ADDENDUM TWO

Addendum Two (AD.02) to the drawings and specifications prepared by Gibraltar Design for **Godare Hall Renovations** for Vincennes University, Vincennes, Indiana.

RE **Pre-Bid Meeting - Question and Answer**
Vincennes University – **Godare Hall Renovations**
Vincennes, IN
Gibraltar Design Project No: 26-115

1 A-701 **FIRST FLOOR EQUIPMENT PLAN - NORTH**

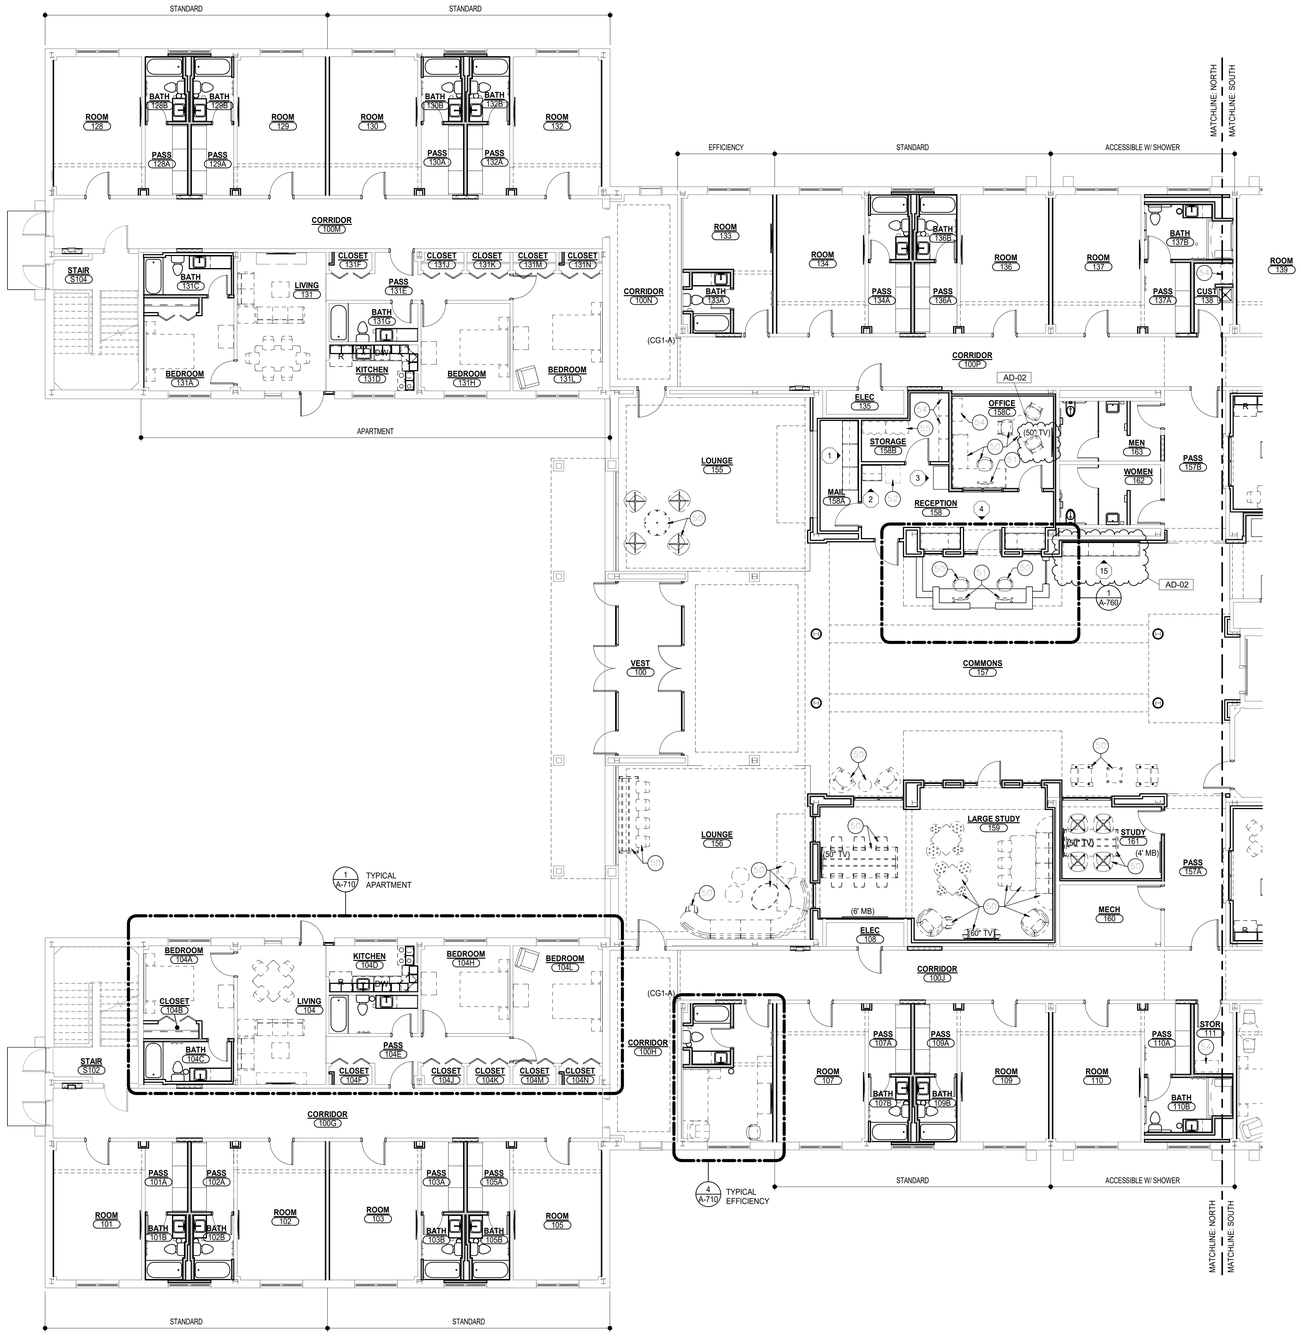
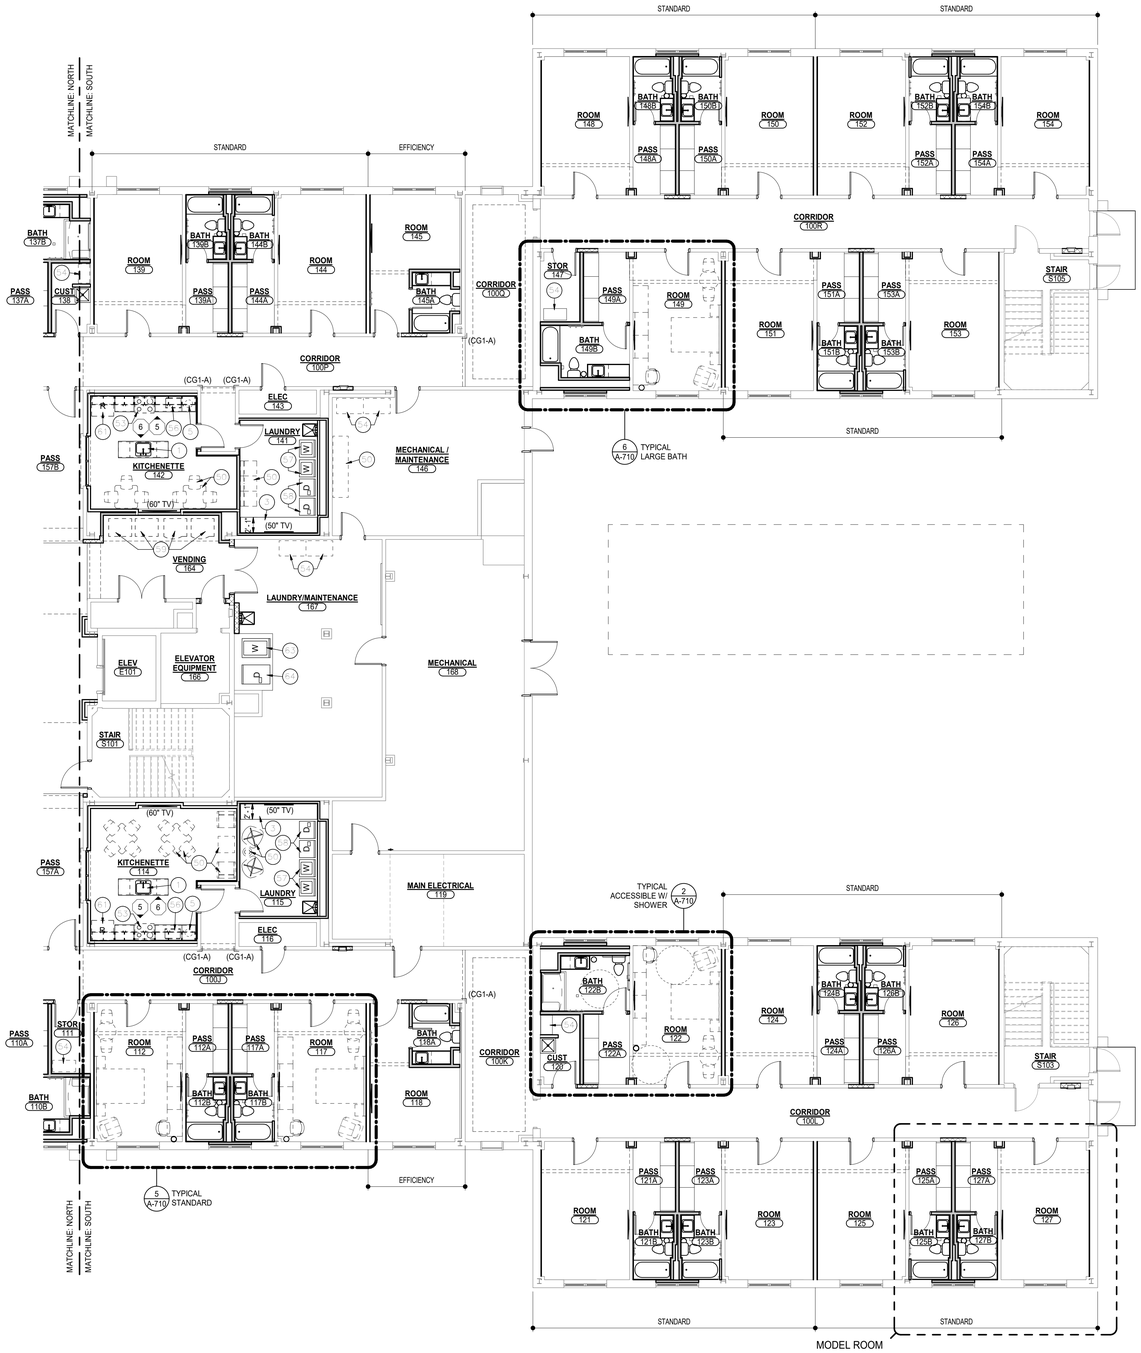
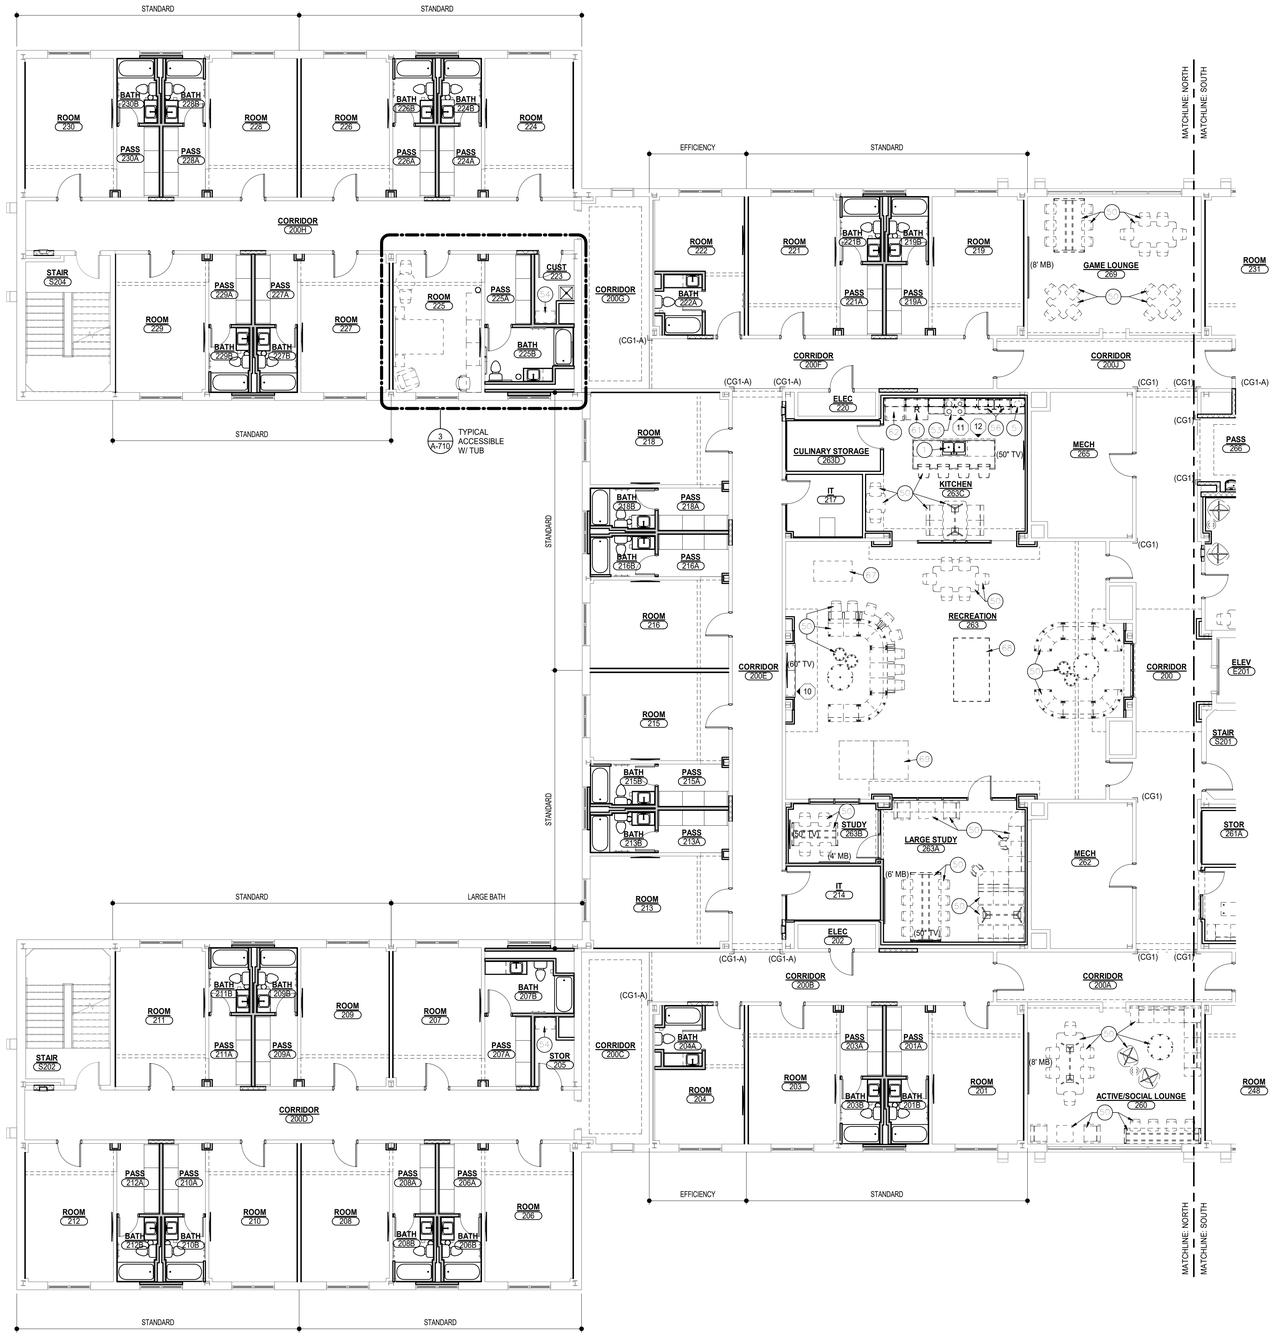
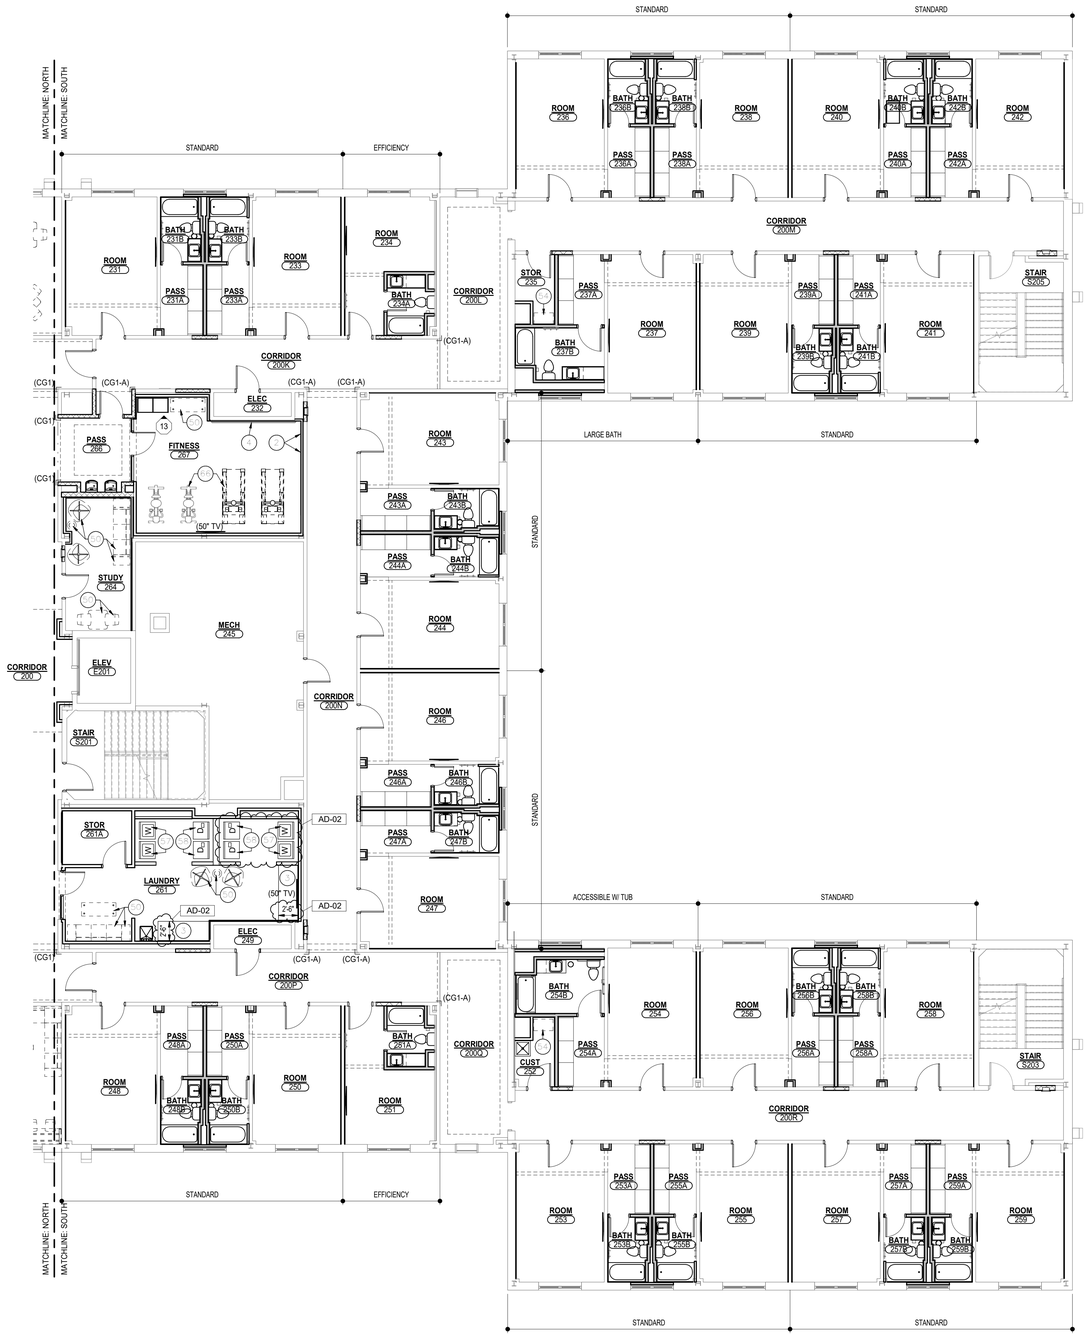
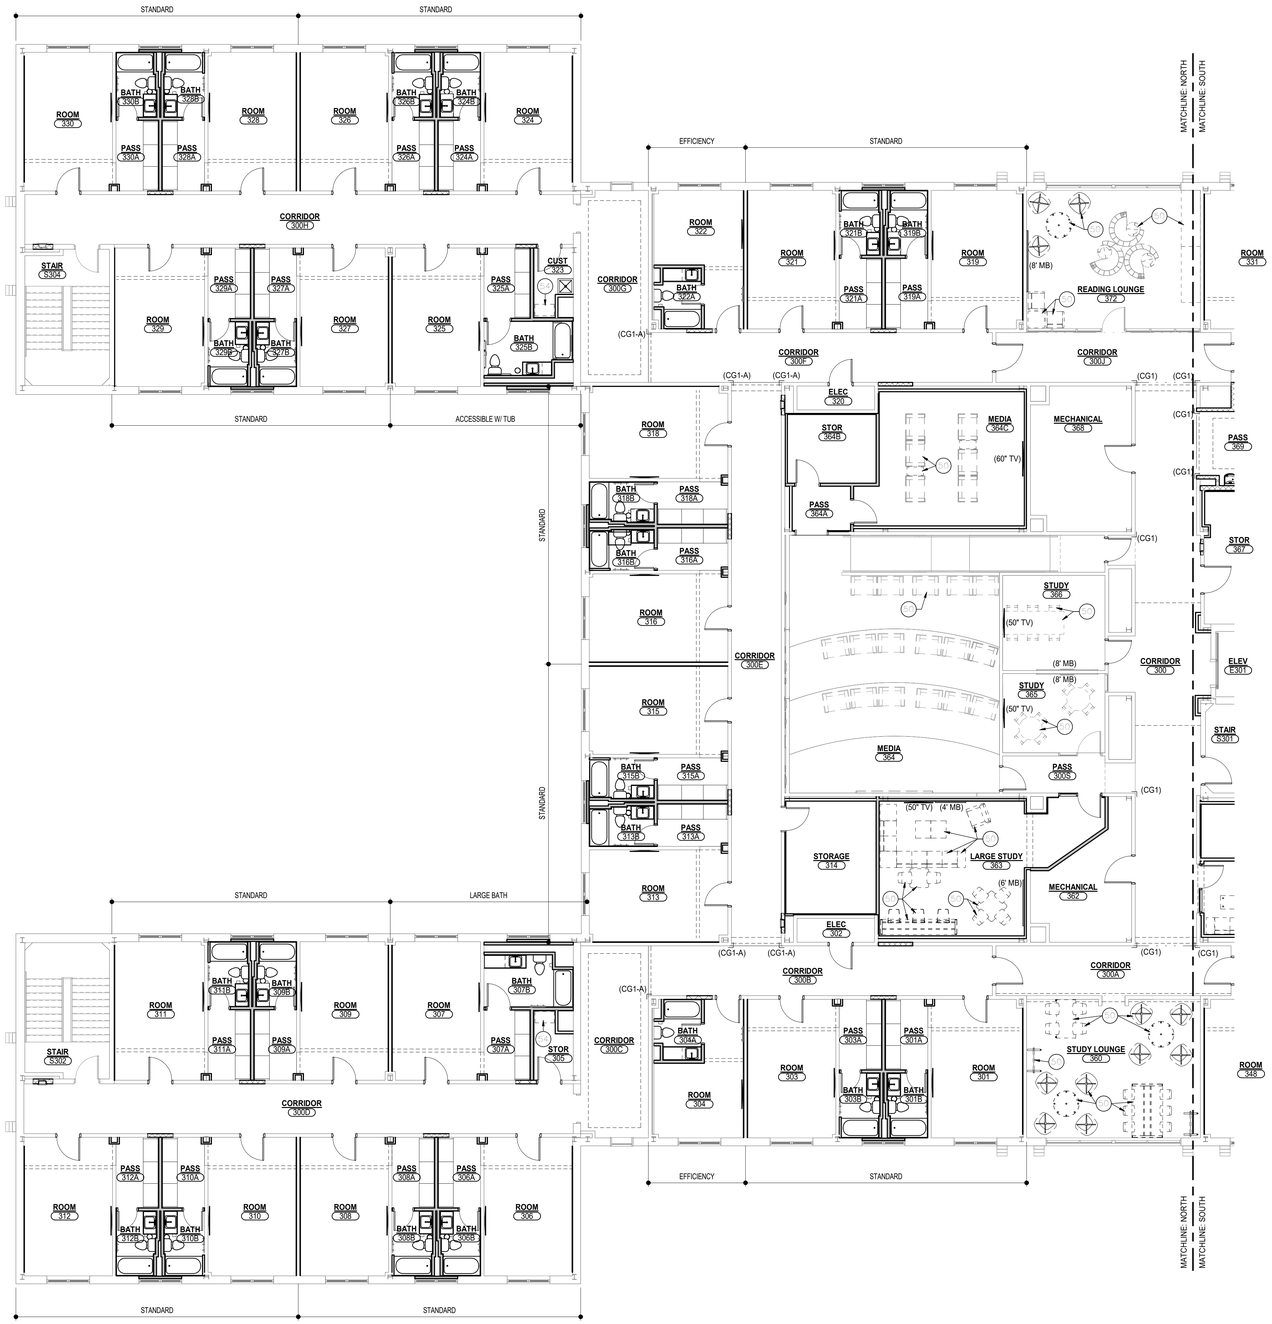
1. Revise visual graphics of loose equipment.
2. Revise plan notes.

3. Add dimensions.
4. Indicate TV locations.

1 A-710 **TYPICAL UNIT-APARTMENT**
1/4" = 1'-0"

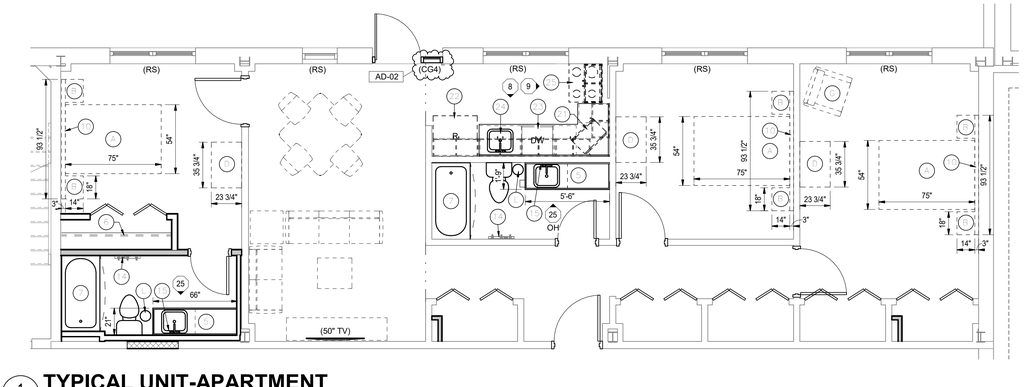
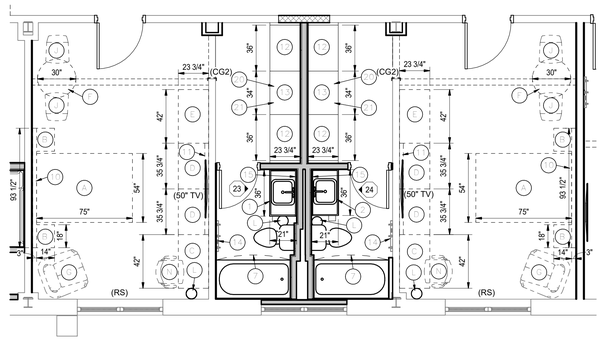
A. Refer to revised, full-size drawing, included in this Addendum, for revisions.
1. Revise visual graphics of loose equipment.
2. Add dimensions.
3. Indicate locations of shower curtain rods.
4. Revise vanity A and B elevations.

2 A-820 **FLOOR TRANSITION DETAILS**
6" = 1'-0"

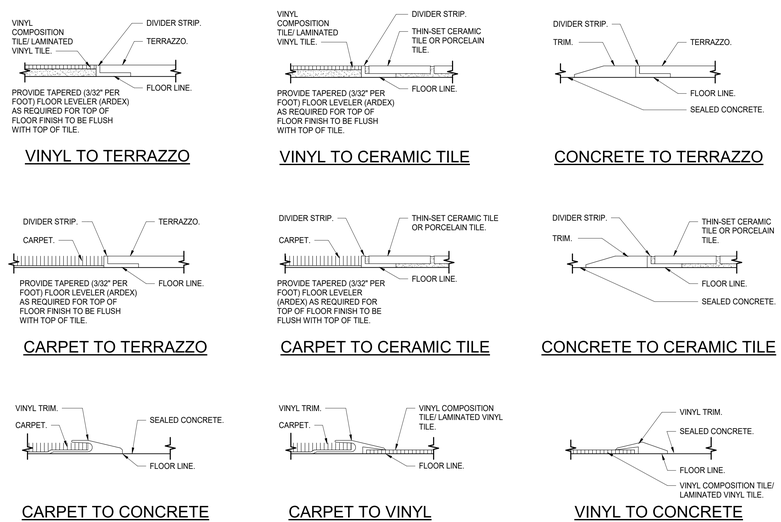
A. Refer to revised, full-size drawing, included in this Addendum, for revisions.
1. Add quartz, QZ.
2. Add aluminum trim, TR.
3. Revise wall protection panel, WPP.
4. Revise wall tile, WT.
5. Add detail 3/A-820.
